Ψ
	Application No.	Applicant(s)
Nation of Allered Hiller	10/705,672	CLARK, WILLIAM T.
Notice of Allowability	Examiner	Art Unit
	William H. Mayo III	2831
The MAILING DATE of this communication appears on the cover sheet with the correspondence address All claims being allowable, PROSECUTION ON THE MERITS IS (OR REMAINS) CLOSED in this application. If not included herewith (or previously mailed), a Notice of Allowance (PTOL-85) or other appropriate communication will be mailed in due course. THIS NOTICE OF ALLOWABILITY IS NOT A GRANT OF PATENT RIGHTS. This application is subject to withdrawal from issue at the initiative of the Office or upon petition by the applicant. See 37 CFR 1.313 and MPEP 1308.

EXAMINER'S AMENDMENT

Applicant: William T. Clark
U.S.S.N.: 10705,672
Entitled: Data Cable With Cross-Twist Cabled Core Profile
Our Ref. No.: M0506-703330
ANNOTATED SHEET SHOWING CHANGES

FIG. 1

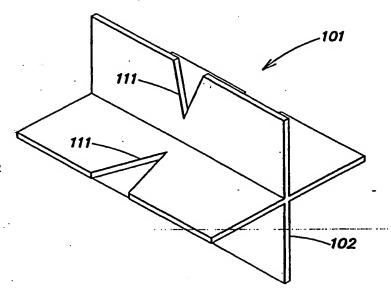
105 105 -103 103 cross hatching has been added to all buisted -107 109 103
